Welch Allyn, Inc. 4341 State Street Road Skaneateles Falls, NY 13153 USA	URGENT: Field Safety Notice	MOD1319
---	------------------------------------	----------------

Commercial name of affected product:
Welch Allyn ELI380 RESTING ELECTROCARDIOGRAPH

Type of action: Field Safety Corrective Action – Software Upgrade

Appendix B
MOD1319 Software Installation Instructions

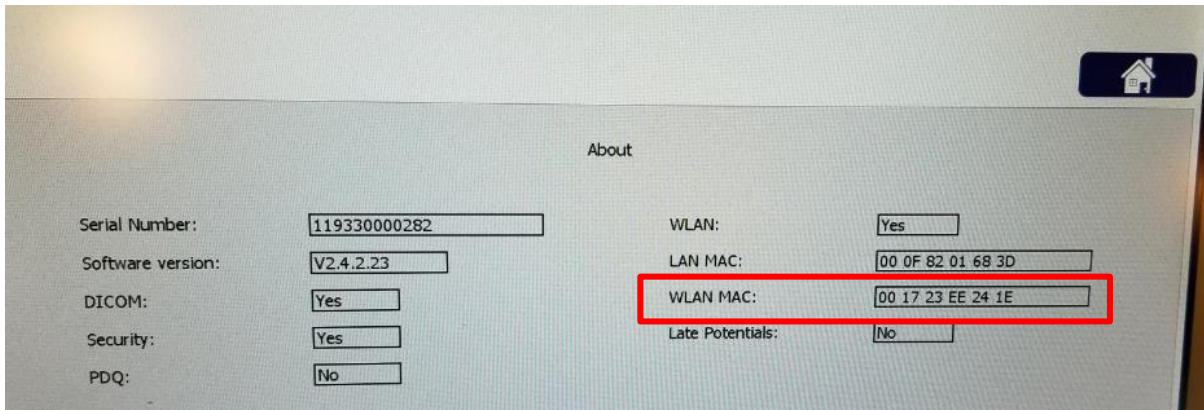
Version 2.4.3 can ONLY be installed on ELI380 units with a Laird WLAN module installed, as indicated by one of the following two labels being present on the bottom of the unit.

If the electrocardiograph is mounted to a transport cart and the bottom of the device is not visible, the WLAN MAC address can be used to determine the type of WLAN module installed in the unit.

The WLAN MAC address contains 12 characters, where the first 6 characters are used to determine the model of the WLAN module installed. The remaining 6 digits will change with each device and is not relevant. Only upgrade units to v2.4.3 that have the MAC address shown below.

MAC address = 00 17 23 xx xx xx

As noted above, software v2.4.3 is not compatible for B&B modules. **If the MAC address is 00 0B 28 xx xx xx, do not perform the software upgrade.**

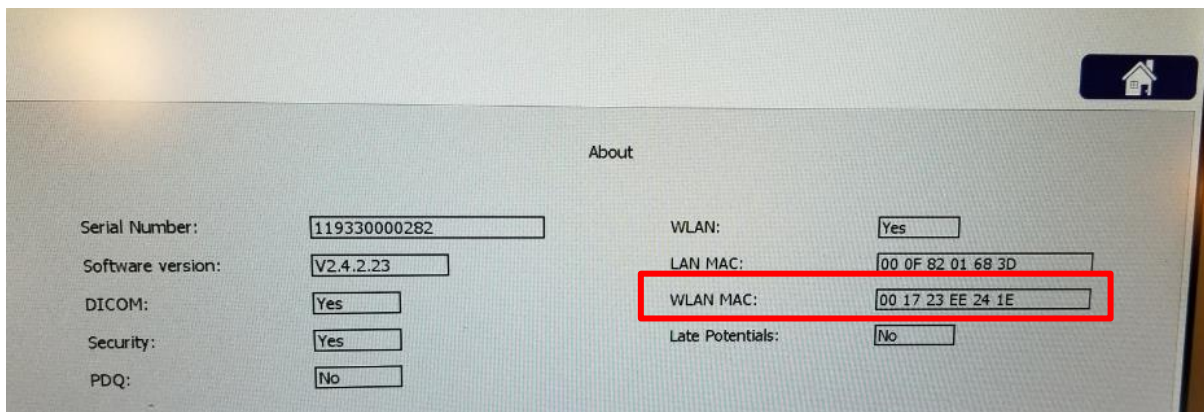
Version 2.4.3 can ONLY be installed on ELI380 units with a Laird WLAN module installed, as indicated by one of the following two labels being present on the bottom of the unit.

If the electrocardiograph is mounted to a transport cart and the bottom of the device is not visible, the WLAN MAC address can be used to determine the type of WLAN module installed in the unit.

The WLAN MAC address contains 12 characters, where the first 6 characters are used to determine the model of the WLAN module installed. The remaining 6 digits will change with each device and is not relevant. Only upgrade units to v2.4.3 that have the MAC address shown below.

MAC address = 00 17 23 xx xx xx

As noted above, software v2.4.3 is not compatible for B&B modules. **If the MAC address is 00 0B 28 xx xx xx, do not perform the software upgrade.**

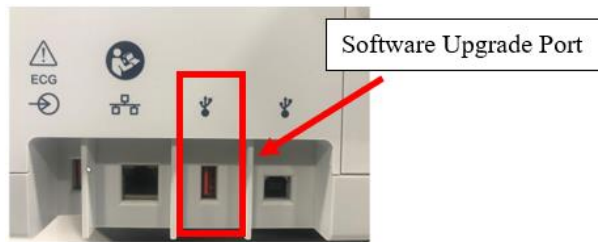
The WLAN MAC address is located under the SETTINGS function of the electrocardiograph and will appear as shown below.
